LACK OF HEAT—BLOWER MOTOR FROZEN—COLD WEATHER CONDITION

TSB 12-12-7

FORD:
2011-2013 Fiesta

The article supersedes TSB 12-1-12 to remove the production fix date and update the vehicle model years.

Figure 1 - Article 12-12-7

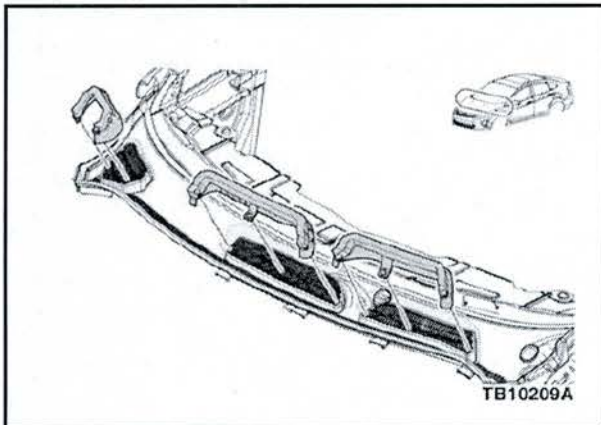
1. Open hood and inspect for presence of deflectors on the air inlets openings of the cowl opening grille. Are deflectors present and properly installed? (Figure 1)

- a. Yes - do not continue with this article. Refer to Workshop Manual (WSM), Section 412-00 for normal diagnostics.

- b. No - install one (1) new deflector onto each of the air inlets of the cowl panel grille. Proceed to Step 2.
2. Inspect operation of the blower motor. Does the blower motor operate properly?
 - a. Yes - release vehicle.
 - b. No - proceed to Step 3.
3. Inspect fuse 4 in the Power Distribution Box. Is the fuse open?
 - a. Yes - proceed to Step 4.
 - b. No - refer to WSM, Section 412-00 for normal diagnostics.
4. Replace fuse. Does blower motor function properly?
 - a. Yes - release vehicle.
 - b. No - refer to WSM, Section 412-00 for normal diagnostics.
